ADDENDUM 2

PROJECT NAME: **ACS Replacement HVAC Kennel B**

DATE: 6/8/21

PROJECT NO.: 35-00209

6 DETAIL - FRAME FOR MECHANICAL DUCT SUPPORT
SCALE : 3/4" = 1'-0"

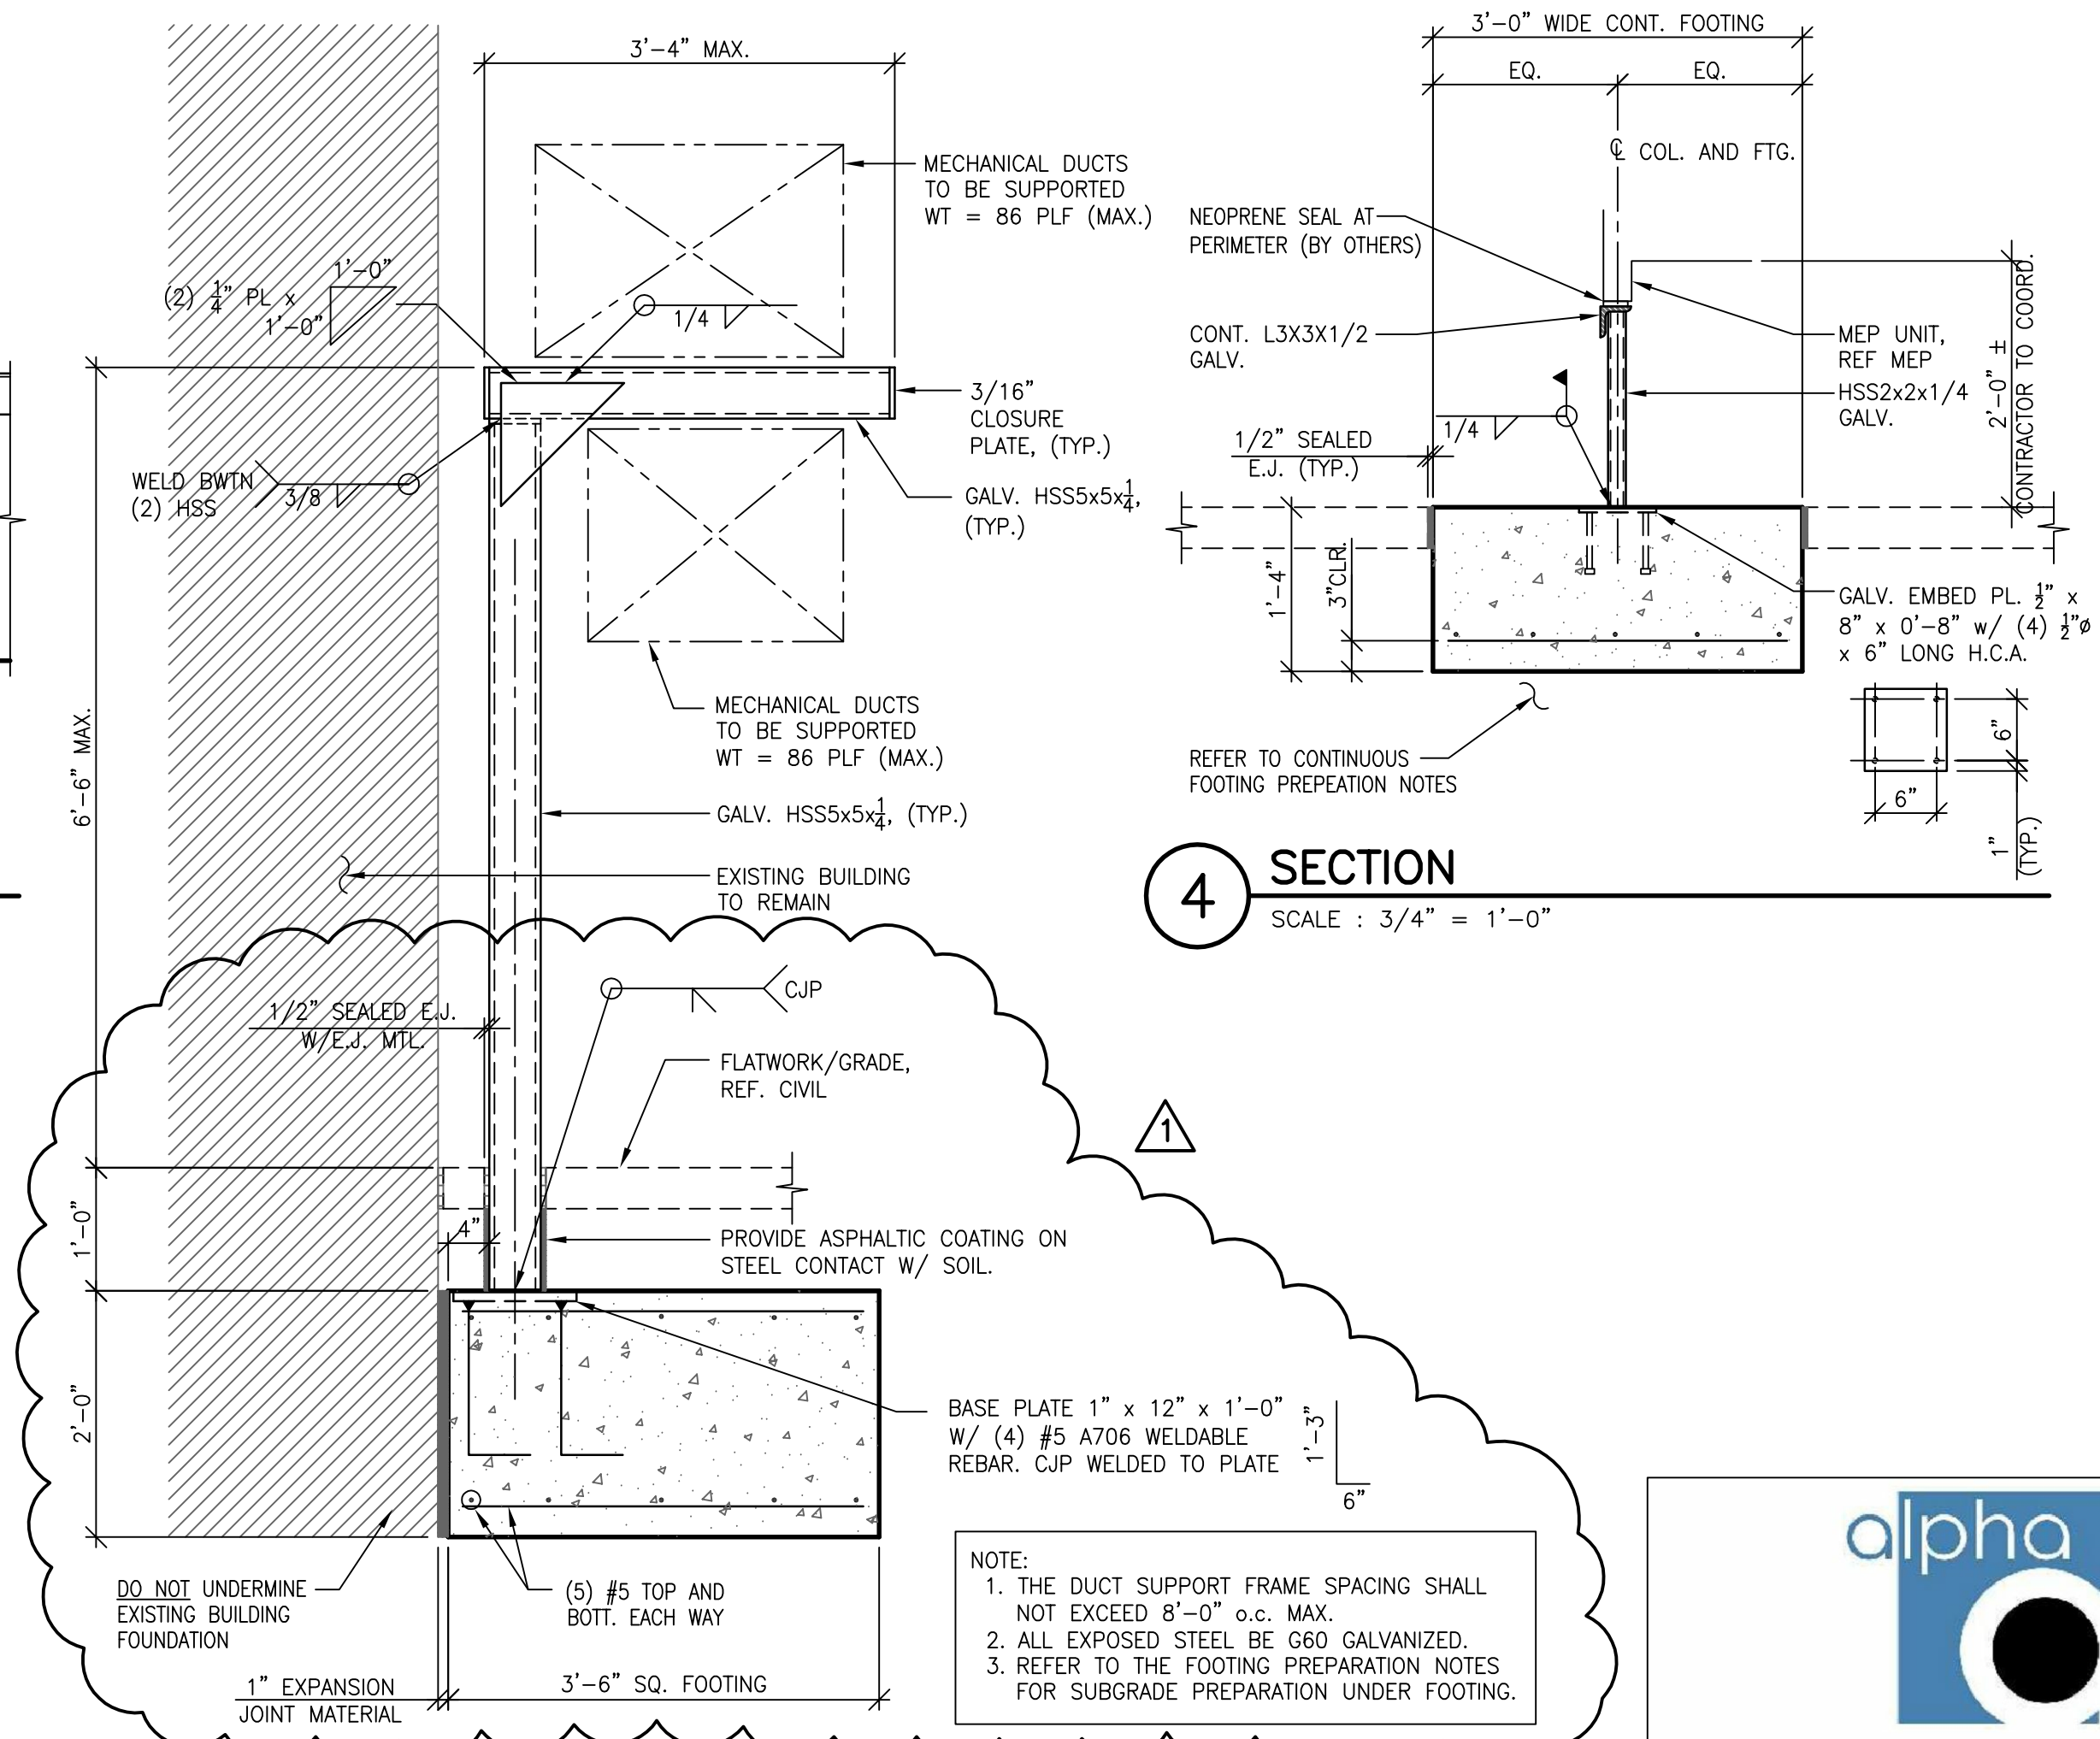
2. Detail 6 on sheet S2.0 concrete work cannot be done as per detail since support has to be installed up against exterior building wall to keep duct as close as possible to wall under roof soffit. Detail shows 21" to center of duct support.

3. There is a sidewalk that runs down the entire length of the duct run. Can duct support shown on S2.0 be installed onto side walk welded onto anchor plate with 1 stud anchor at each corner?

1. REPLACE: Plan Sheet S2.0:
Item 1: Revised detail #6 to show duct support close to the existing building.
2. REPLACE: Plan Sheet M1.1:
Item 1: Added duct supports.
Item 2: Added Keyed Note 15.

Answer: Please refer to the revised detail 6/S2.0.

Answer: Please refer to the revised detail 6/S2.0.

NOTE:
1. THE DUCT SUPPORT FRAME SPACING SHALL NOT EXCEED 8'-0" o.c. MAX.
2. ALL EXPOSED STEEL BE G60 GALVANIZED.
3. REFER TO THE FOOTING PREPARATION NOTES FOR SUBGRADE PREPARATION UNDER FOOTING.

KENNEL B
MECHANICAL FLOOR
PLAN - NEW WORK

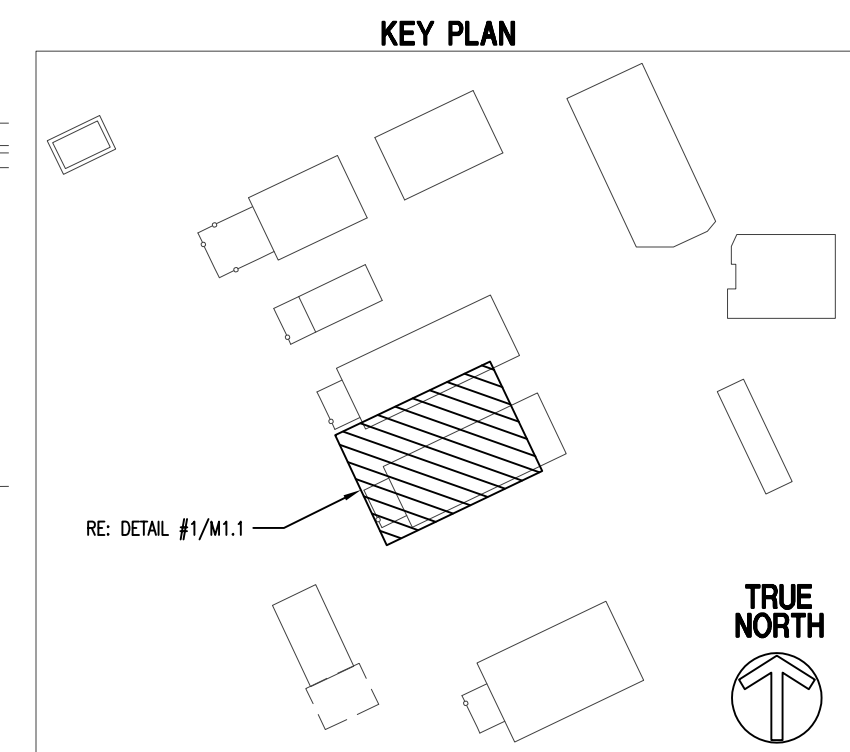
4. Can duct supports shown on sheet S2.0 detail 6 be drawn onto mechanical drawing M1.1 as required so all bidding can bid the same amount of supports? Please advise

Answer: Contractor to coordinate with MEP and Structural drawings. Please make sure that the support spacing is 8 ft. max. Please refer to revised sheet M1.1.
